From:
Sent: 04 October 2018 14:17
To: Helen Webster
Subject: RE: NYM/2018/0526/FL - The Bank House, Grosmont

Drawing
**Floorplans, Section and Elevations
as Proposed**

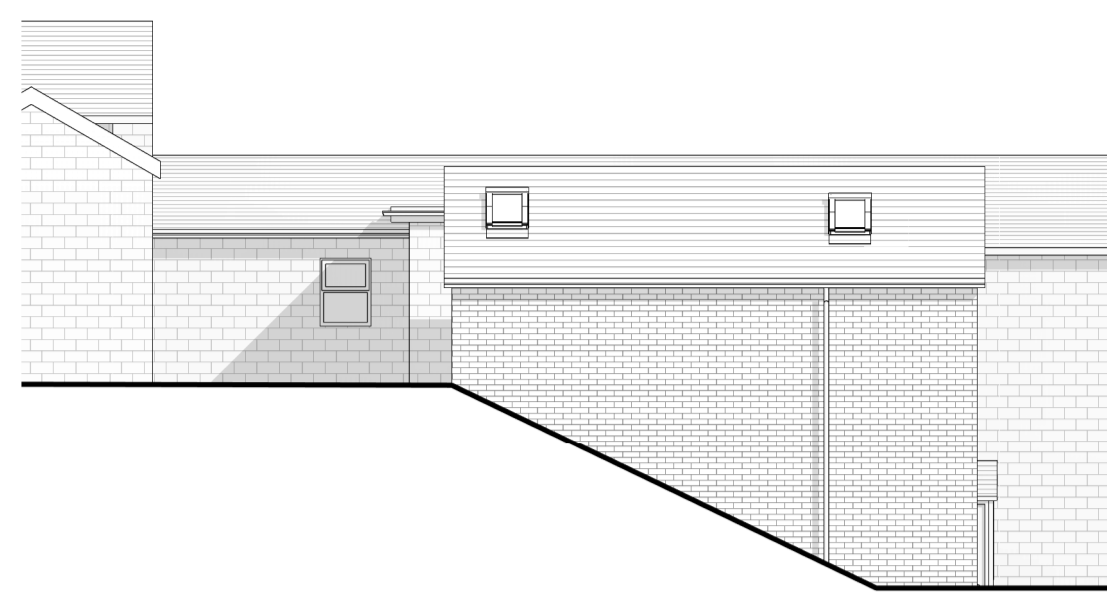
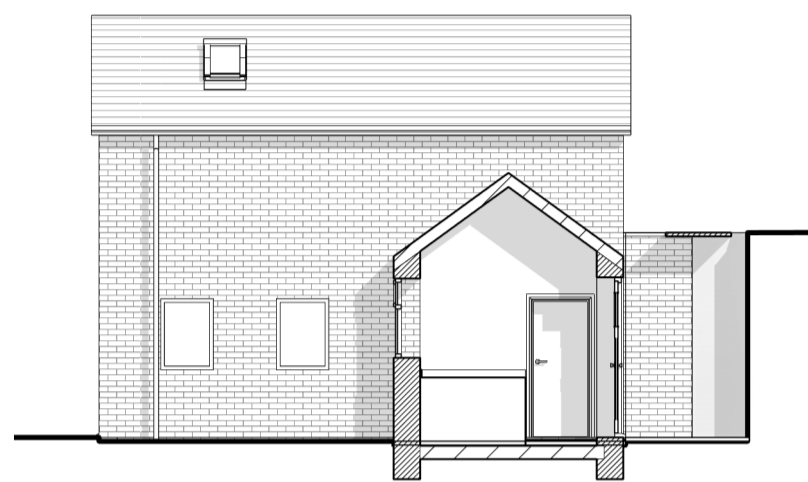
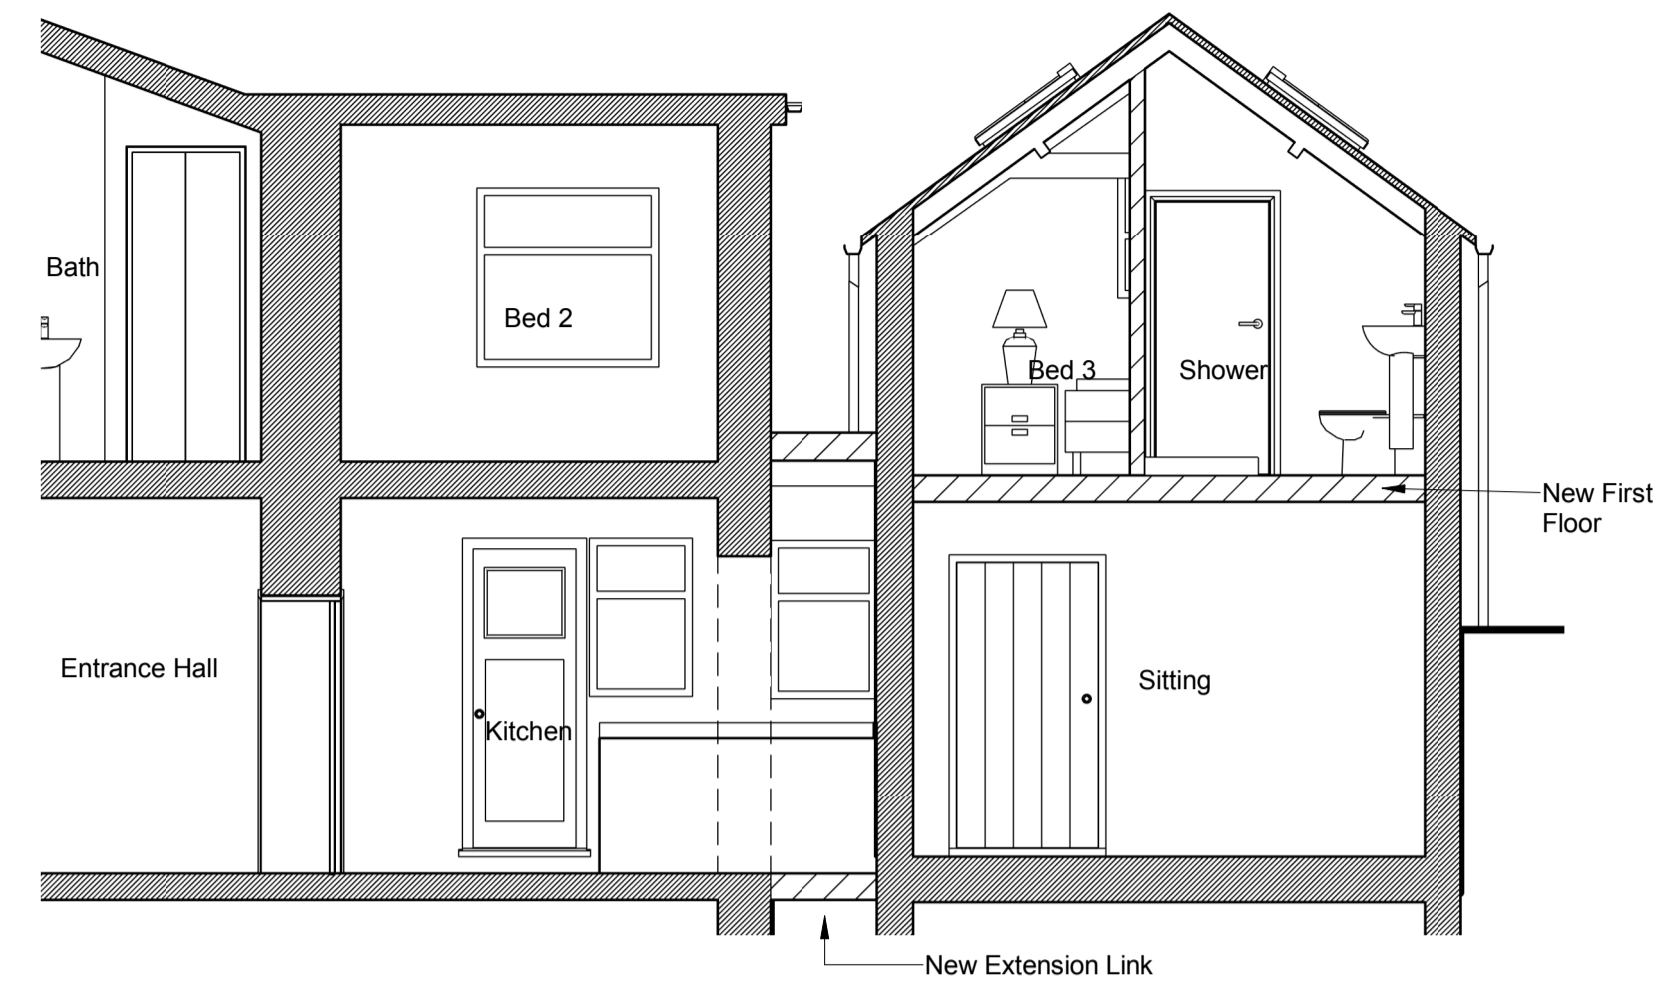
The above application is currently being processed and due for determination tomorrow. However, it has just come to my attention that the drawing: 'Floorplans, Section and Elevations as Proposed' 1786 P1 Rev B has the elevations incorrectly labelled 'as existing'. For the avoidance of doubt, is it possible to issue a revised plan to me, amending the annotations to 'as Proposed'?

Thank you for the e mail, I apologise for the incorrect labelling and please find attached a pdf copy of the Revised drawing 1785 – P1C.

C	Amended Titles	04/10/18
B	Amended Drawing	10/08/18
A	Amended Drawing	23/07/18
#	First Issue	02/07/18
